ADDENDUM

Elevation Place Climbing Gym Floor Replacement CAP 7408	ADDENDUM NUMBER:	01
	DATE OF ISSUE:	12 March 2025
	ISSUED BY:	Mike Ford
	PAGE(S):	7

Photo 1 - Advanced Climbing and Bouldering corridor – Overhead View looking east

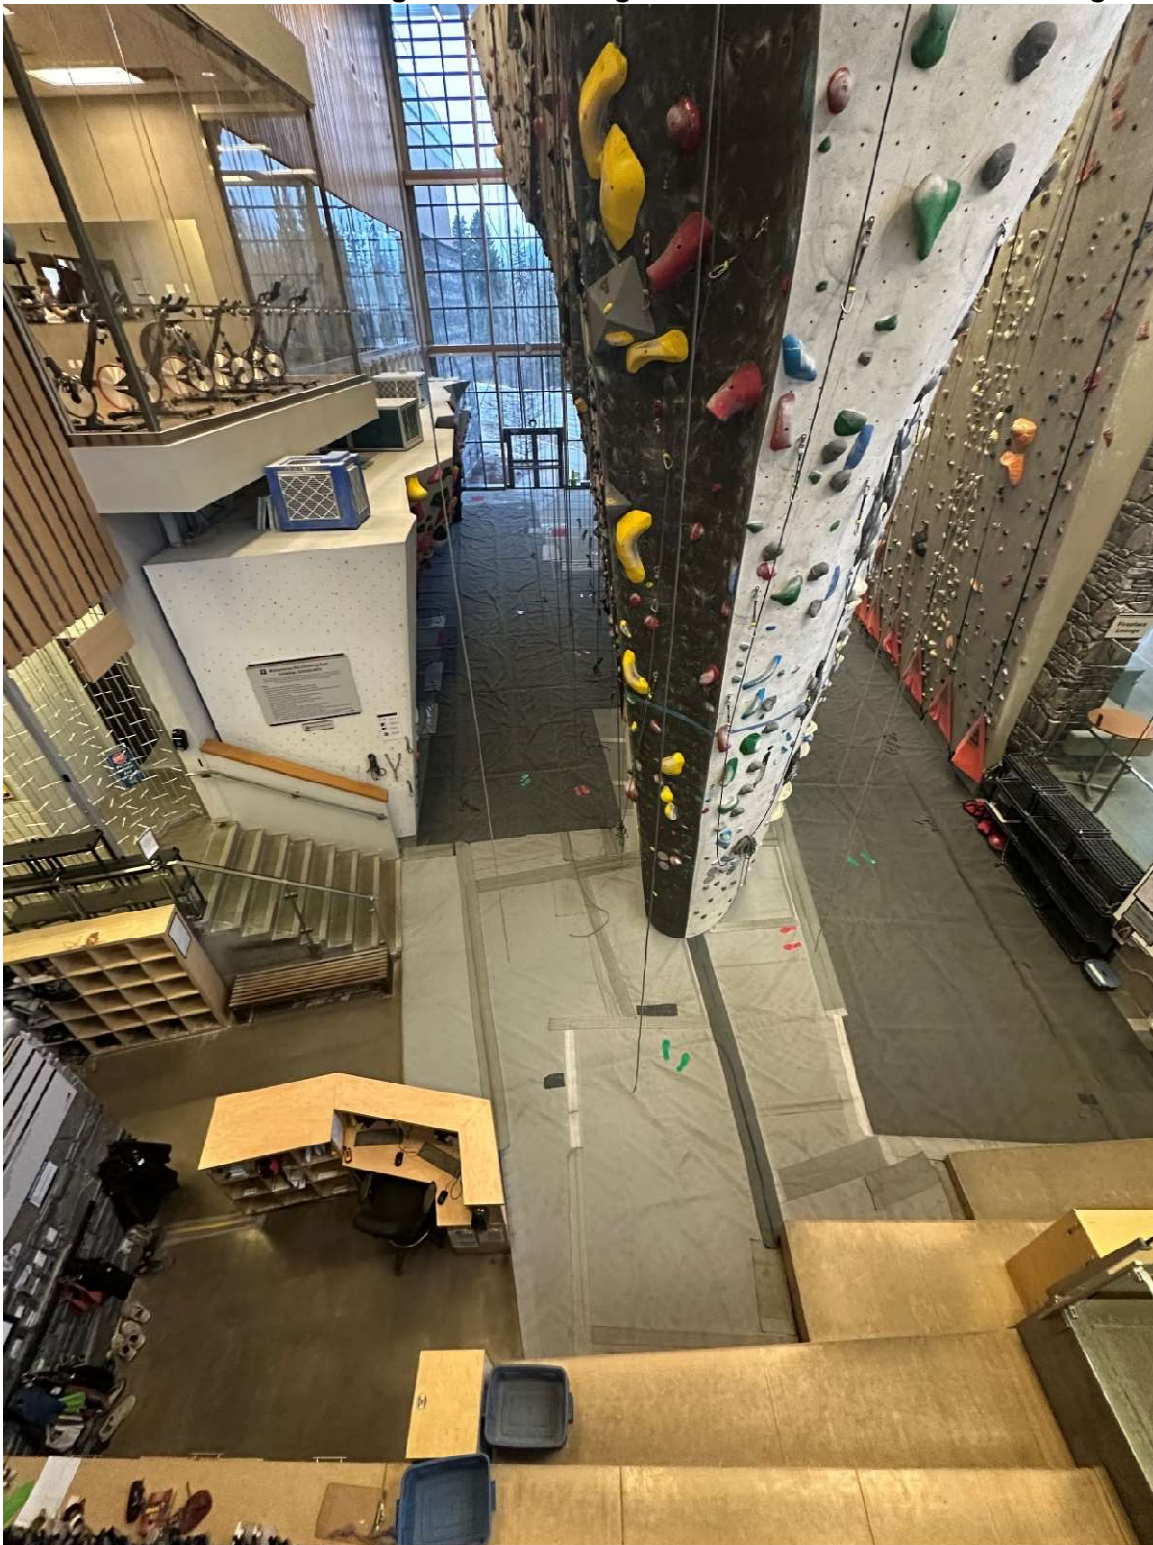
10. Question – Can you send photos of the Climbing Gym when it is not as busy?

Answer: Please see the photos attached.
